### **Response to Consultation on Arnside and Silverdale AONB DPD**

**Response to Pre-publication Consultation on Suggested Additional Allocation Sites  
- Arnside and Silverdale AONB Development Plan Document**

**Suggestion 2: Storth**

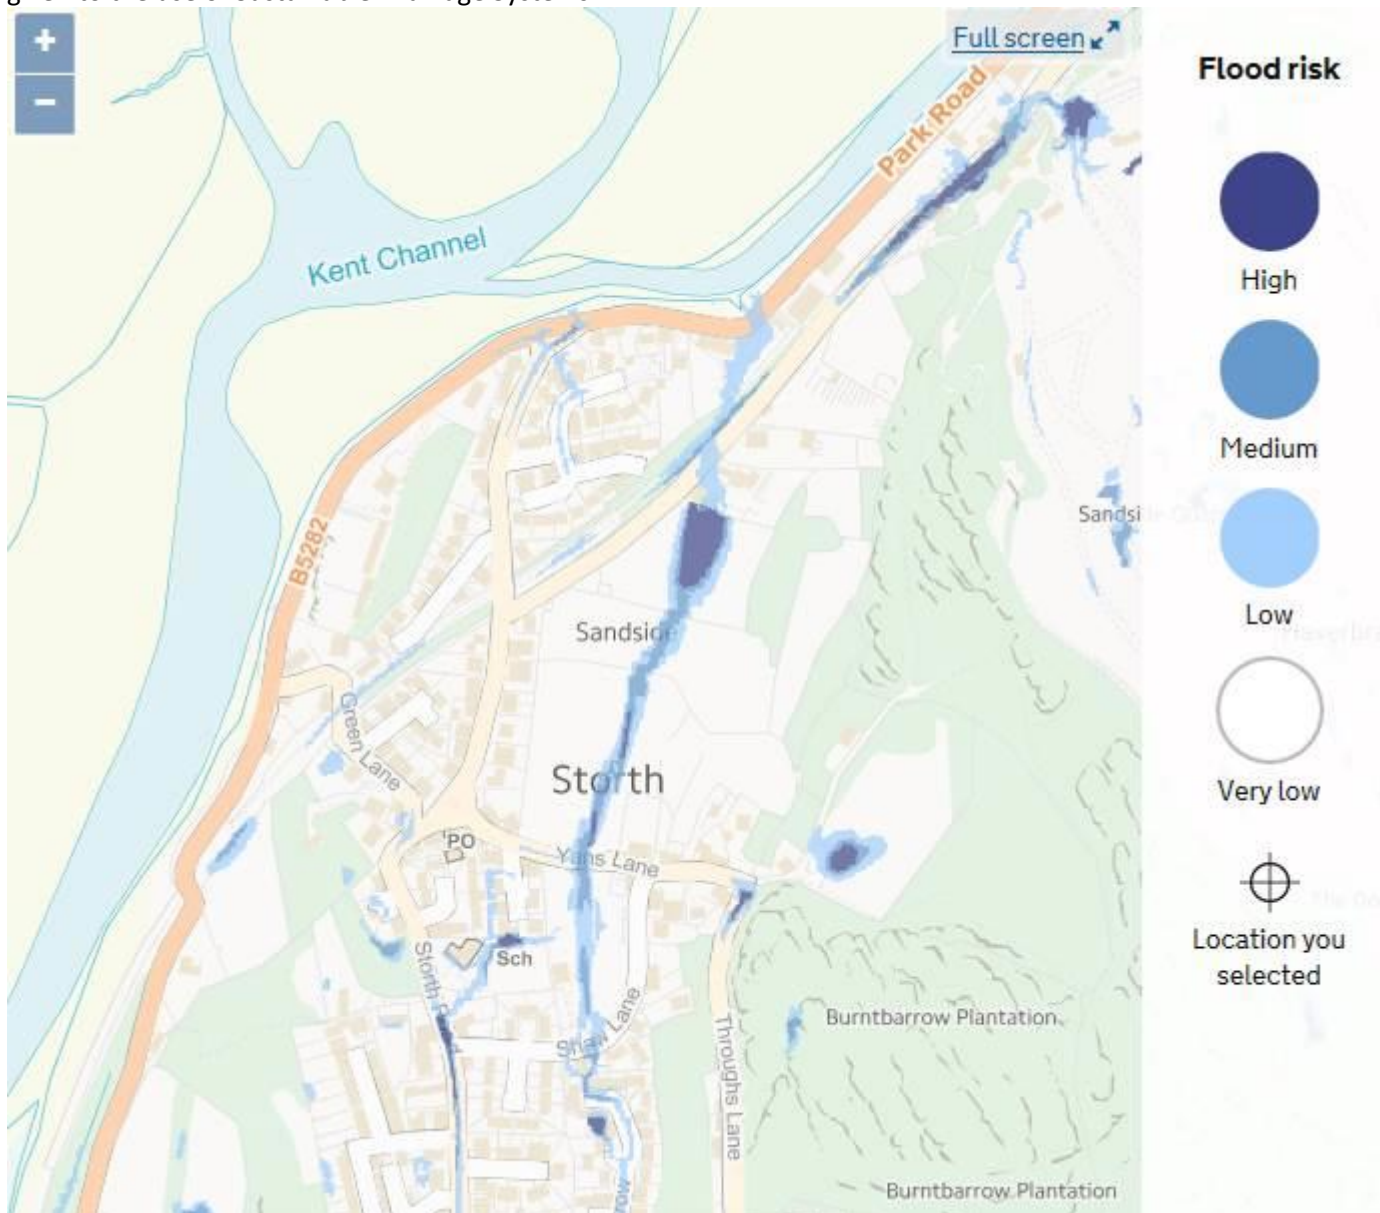
Access seems possible with some minor works needed both on Park Road and internal routes.

This site has been extended to include a large linear surface water feature as shown below and is almost certainly an unmapped watercourse. Previous comments are applicable. Priority must be given to the use of Sustainable Drainage Systems.
